# VESTEL Change Bulletin

**SUBJECT :** Spare Parts :Changing Power Board from  
17PW15 to 17PW20

**DATE :** 28.11.2007

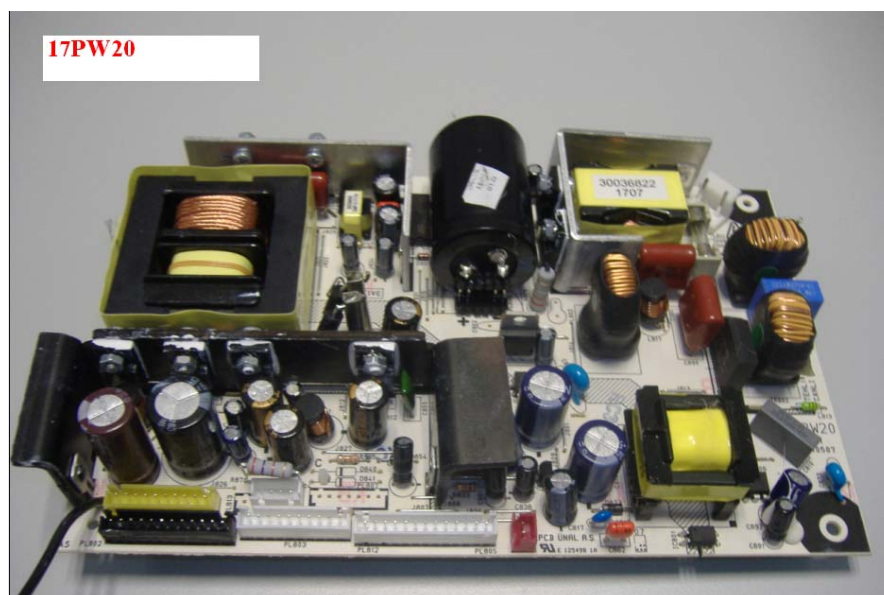
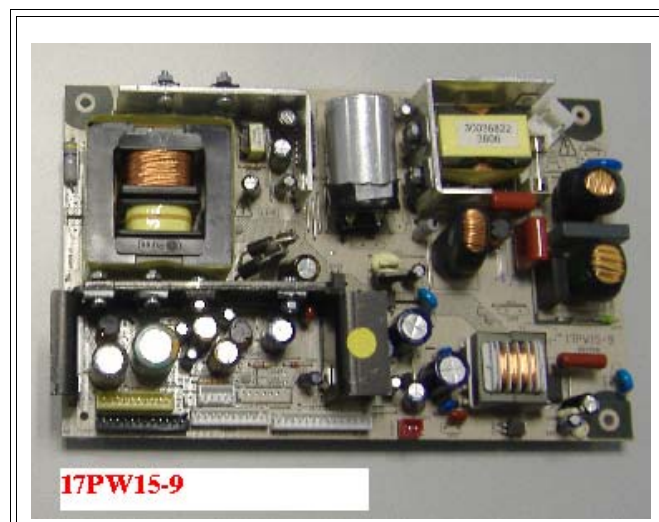
Deska zdroje 17PW20 muze byt pouzita misto 17PW15, tyto desky jsou kompatibilni.

S touto deskou bude spotreba mene nez 1W : 17PW20

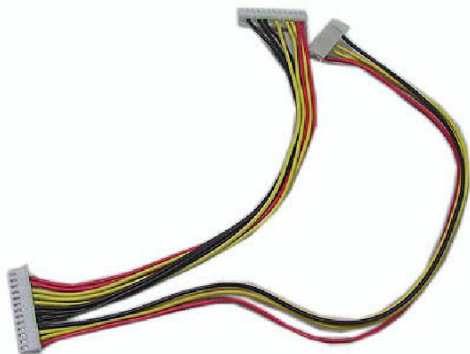
1. Není potřeba měnit kabely při výměně 17PW20 za **17PW15-9** .

Kabely jsou stejné u 17PW20 i 17PW15-9

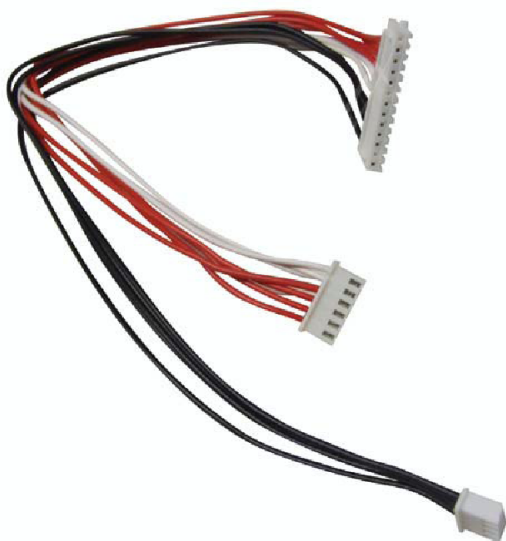
3. Výměna kabelu je NUTNÁ při výměně 17PW20 v modelech s **17PW15 a sasi MB08**

30055597 CNAS 13P+6P/250+4P/300SIS W/3CUL1007ROHS
